Enclosure 1, Attachment 1 to MFN 07-485

**Response to Portion of NRC Request for
Additional Information Letter No. 88
Related to ESBWR Design Certification Application
ESBWR Probabilistic Risk Assessment
RAI Numbers 19.1-96, 19.1-102 through 19.1-108
and 19.1-110 through 19.1-115**

Case 2: Loss of SDC @ 8 hours, 3 DPVs, GDCS

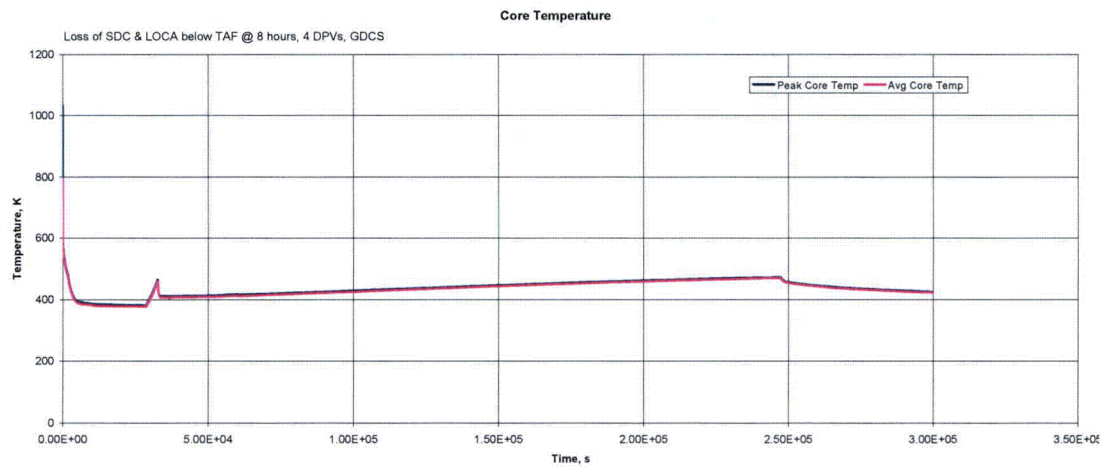
The safety functions of 2 GDCS lines, 2 GDCS pools, 1 equalizing line and 4 DPVs describe core cooling using passive injection systems. For these analyses, it was assumed that passive containment cooling was not operating. MAAP thermal-hydraulic uncertainty analyses for transients, such as loss of SDC, indicate that depressurization using 3 DPVs, injection using 1 GDCS injection line from 2 GDCS pools and opening the equivalent of less than 1 equalizing line prevents core damage for greater than 72 hours as shown in Case 2. It should be noted that the model used was not 1 GDCS injection line from each of the 2 GDCS pools but 1 injection line from the total of two GDCS pools.

Case 4: Loss of SDC & LOCA above TAF @ 8 hours, 4 DPV, GDCS

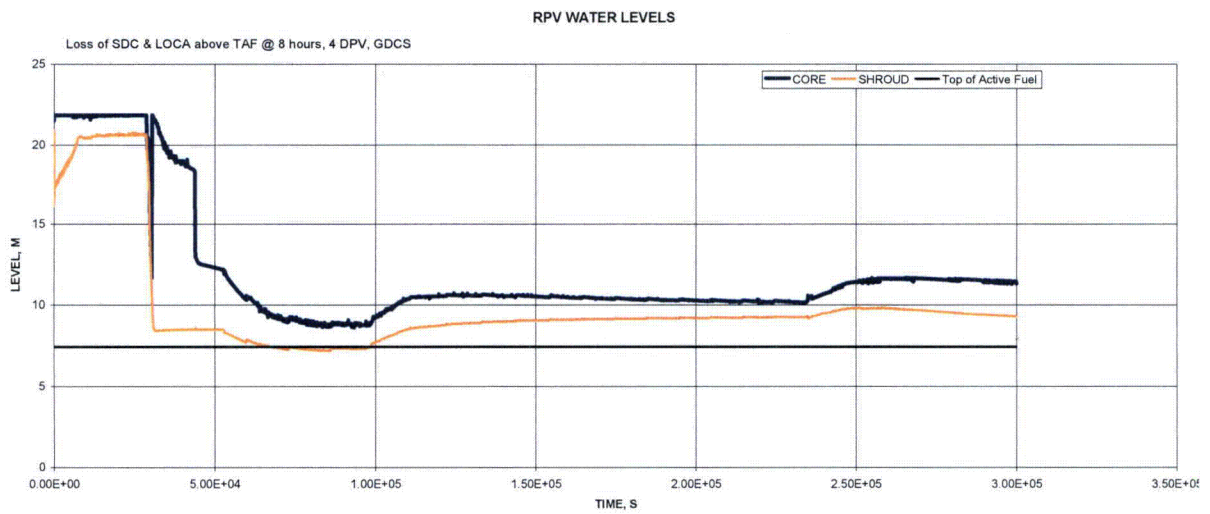
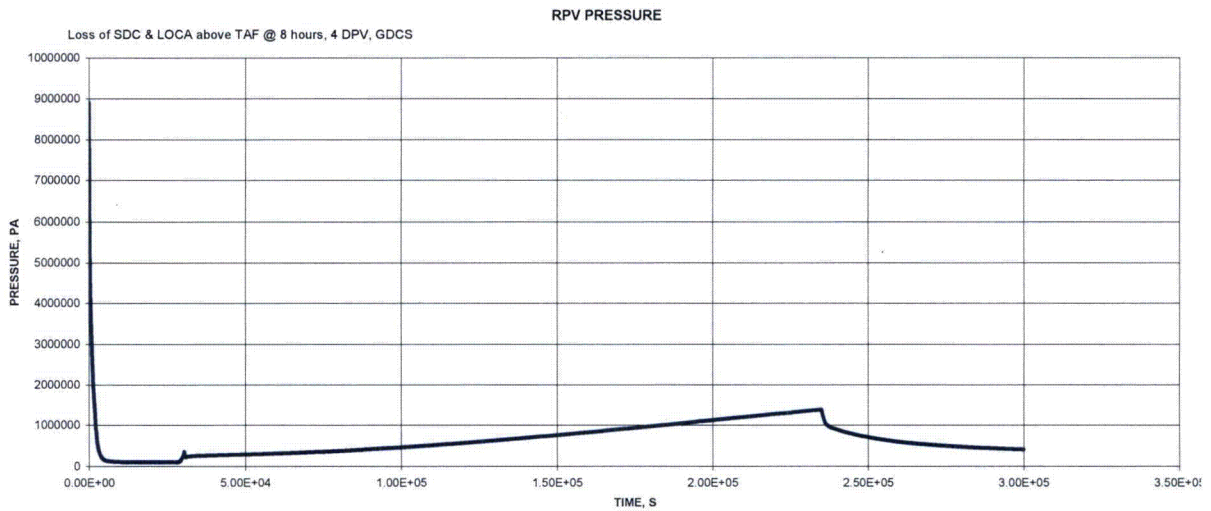
MAAP thermal-hydraulic uncertainty analyses for LOCAs above the top of active fuel indicate that depressurization using 4 DPVs, injection through 1 GDCS injection line from 2 GDCS pools and opening the equivalent of less than 1 equalizing line prevents core damage for greater than 72 hours as shown in Case 4.
